Access Compliance Report

Public Rights-of-Way

(Curb Ramps)

Intersection ID: 32079	Main Street: ASHGROVE_LN	Cross Street: KEEGAN_WY	Location: S
ADA ID: DA5F0F84BC0D	Ramp Type: PerpDiag	Initial Pass/Fail: Fail	Overall Compliance: No
Severity Score: 60			
Codes/Mitigation Info/Possible Solution		Field Measurements/Component Compliance

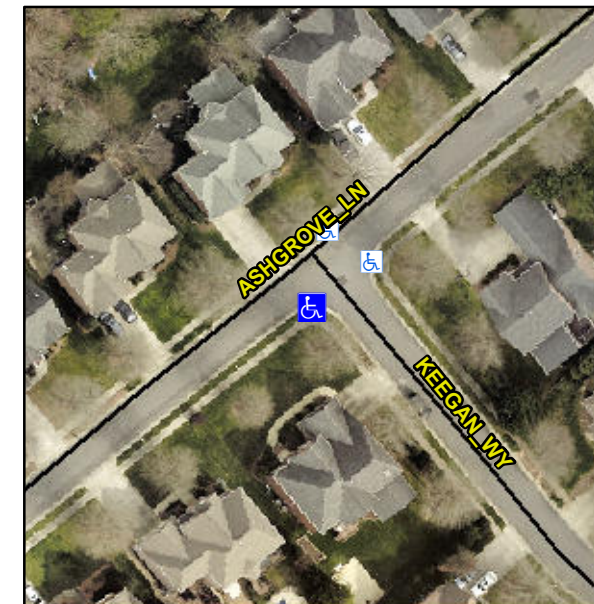
Not Found, R304.5.1, R304.5.3

Compliance	Description	Data	Compliance	Description	Data
N/A	Ramp Length (in)	55.5	Yes	Ramp Slope (%)	6.2
No	Ramp Width (in)	31.5	No	Ramp XSlope (%)	11.3
N/A	Flare Type LT	N/A	N/A	Flare Type RT	N/A
N/A	Flare Slope LT (%)	N/A	N/A	Flare Slope RT (%)	N/A
N/A	Flare Traversable LT?	N/A	N/A	Flare Traversable RT?	N/A
N/A	Landing Length (in)	N/A	N/A	DWS Provided?	N/A
N/A	Landing Width (in)	N/A	N/A	DWS Contrast?	N/A
N/A	Landing Slope (%)	N/A	N/A	DWS Length (in)	N/A
N/A	Landing X Slope (%)	N/A	N/A	DWS Full Width?	N/A
N/A	Landing Curb? (Y/N)	N/A	N/A	DWS Offset (in)	N/A
N/A	Shared Landing?	N/A			
N/A	Gutter Ponding?	N/A	N/A	Gutter Slope (%)	N/A
N/A	Gutter Lip Ht (in)	N/A	N/A	Gutter X Slope (%)	N/A
N/A	Painted X Walk1?	No	N/A	Painted X Walk2?	No
	X Walk 1 Direction	To NE		X Walk 2 Direction	To NW
N/A	X Walk 1 Width (in)	N/A	N/A	X Walk 2 Width (in)	N/A
	X Walk 1 Slope (%)	1.8		X Walk 2 Slope (%)	5.7
	X Walk 1 X Slope (%)	7.6		X Walk 2 X Slope (%)	2.6

Possible Solutions:

Remove & Replace Curb Ramp With Two New Directional Ramps or Equivalent.
